Product Change | Skyline Hardware

We will be implementing revisions to our Skyline portfolio and will discontinue the previous version. These changes will help to improve inventory management and labor times, with the added benefit of saving on cost.

Skyline Clutches – Will no longer require SLA adapters.

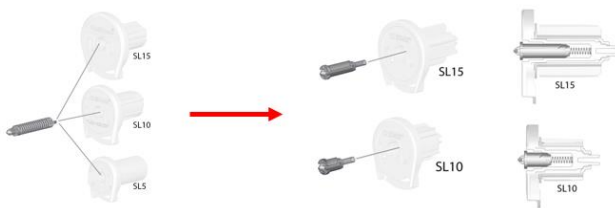
- We will continue selling the RA2 and RA25 adapters for larger tubes.
- No change to SL20 and SL30, nor to the exterior versions.
- Will continue to sell geared (galaxy) clutches.
- White (075) revised to pure white (069).

Old Part	Tube Size	New Part
SL10H01xx / SL10H02xx	1.125"	SL10-0105-xxx028
SL10H01xx / SL10H02xx	1.25"	SL10-0101-xxx032
SL10H01xx / SL10H02xx	1.5"	SL10-0102-xxx038
SL15H01xx / SL15H02xx	1.5"	SL15-0102-xxx038
